September 11, 2007
LIC-07-0082

**SUBJECT: Fort Calhoun Station, Unit No. 1, License Amendment Request (LAR)
"Permanent Use of Sodium Tetraborate as the Containment Building Sump
Buffering Agent"**

Proposed Technical Specification Changes (Markup)

Figure 2-3
NaTB Volume Required for RCS Critical Boron Concentration (ARO, HZP, No Xenon)

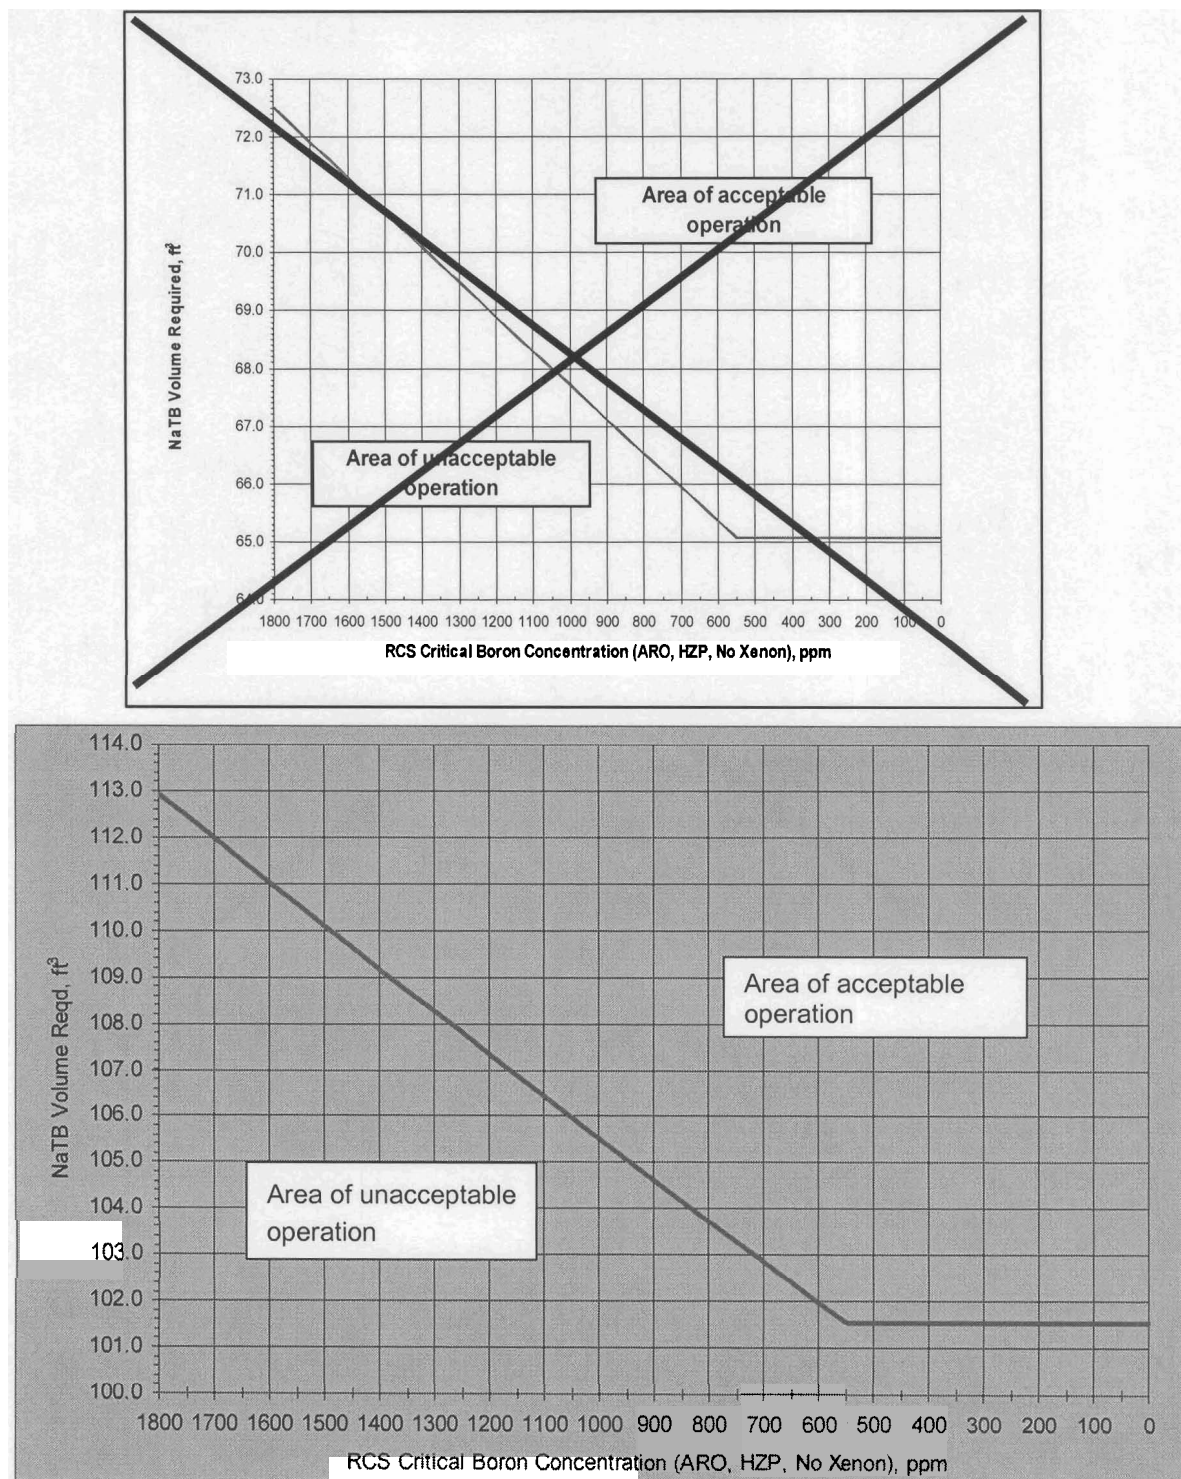
TS 2.3(4), Figure 2-3 shows the minimum required volume of buffering agent as Hot Zero Power (HZIP), Critical Boron Concentration (CBC) decreases over the operating cycle. The volume of NaTB required by Figure 2-3 will be increased to allow the use of lower density NaTB from a new vendor. The revised volume also reflects an increase in the mass of NaTB to provide a slight increase in pH control margin with minimal impact on EEQ margin. The proposed changes ensure that the post-LOCA containment sump pH is ≥ 7.0 , the proposed changes are bounding for all operating parameters, and thus the proposed changes are suitable for long-term operation.

The Basis of TS 3.6 is revised to account for the increased volume of NaTB required by Figure 2-3. Since the NaTB density is lower, the Basis of TS 3.6 is revised to incorporate the corresponding mass and volume increase necessary to achieve containment sump pH ≥ 7.0 . Consequently, the size of the NaTB sample from the sump used to measure buffering ability was also increased slightly. The increased mass and volume of NaTB required when FCS is in Operating Modes 1 and 2 was determined using the same methodology used to evaluate the use of NaTB in Reference 4, provided as an attachment to Reference 5. The TS 3.6 Basis changes are provided for information only and will be

The proposed amendment permanently changes the containment sump buffering agent specification from TSP to NaTB. The footnotes of TS 2.3(4) and TS 3.6(2)d stating, "This specification is applicable only for Fuel Cycle 24" are deleted. Figure 2-3 is revised to reflect a new minimum volume required to achieve a post-LOCA sump pH of ≥ 7.0 . The revised figure reflects a lower density of NaTB due to a change in the vendor and an increase in the mass of buffer to ensure that the resulting post-LOCA sump pH is slightly greater than 7.0.
